UNITED STATES PATENT AND TRADEMARK OFFICE

APPLICATION NO.	FILING DATE	FIRST NAMED INVENTOR	ATTORNEY DOCKET NO.	CONFIRMATION NO.
09/830,388	08/10/2001	David Collier	COL001	7101

Office Action Summary

DETAILED ACTION

3,392,534

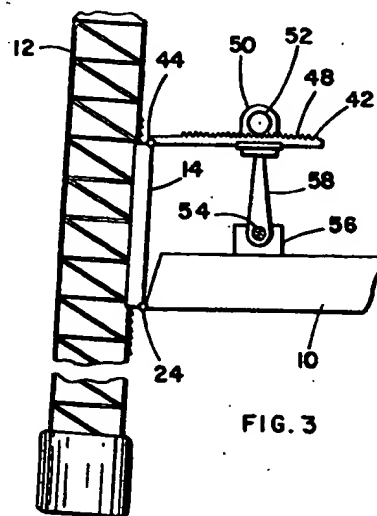
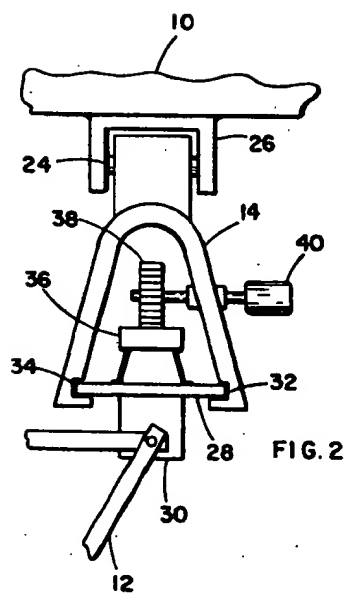
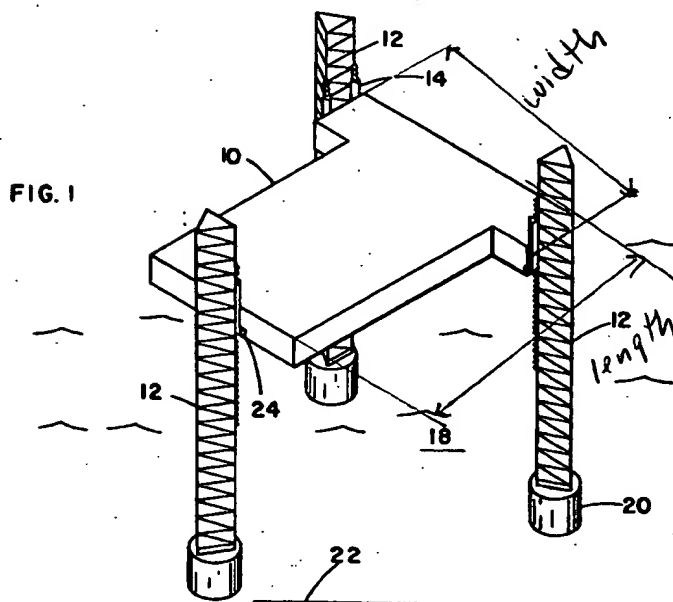
Blenkarn discloses an offshore structure comprising a base (20), a substantially rectangular deck (10) having a width and a length with the width being defined between two substantially parallel side edges (see attached marked up Figure 1 for interpretation of parallel side edges) and the length being defined between two additional side edges (see attached marked up Figure 1 for interpretation of the additional side edges), a plurality of legs (12) extending substantially perpendicular to their respective bases between the bases and the deck, wherein the plurality of legs are attached to their

respective bases outboard of said parallel side edges so as to be spaced a distance greater than the width of the deck such that the deck is positioned entirely between opposing ones of the plurality of legs while the length of the deck is greater than a distance between adjacent ones of the plurality of legs, and a connection is provided directly between an inwardly facing face of each of the plurality of legs and a respective one of the parallel side edges of the deck such that the deck is fixed to the plurality of legs (see all the figures). Each said leg comprises a vertically extending chord at each corner thereof. Each said chord is circular in cross section. Each leg is triangular.

Blenkarn discloses the invention substantially as claimed. However, Blenkarn lacks a singular base attached to all the legs. Corder teaches a singular base (12) attached to a plurality of legs. It would have been considered obvious to one of ordinary skill in the art to modify Blenkarn by substituting the base as taught by Corder for the plurality of bases disclosed by Blenkarn since such a modification would provide stability along the seabed.

It should be noted that the limitation “the length of the deck is greater than a distance between adjacent ones of the plurality of legs” has been met since the examiner is considering the “adjacent legs” to be the legs that lie in the plane of the width of the deck and since the length of a rectangle is longer than the width the above mentioned limitation is met.
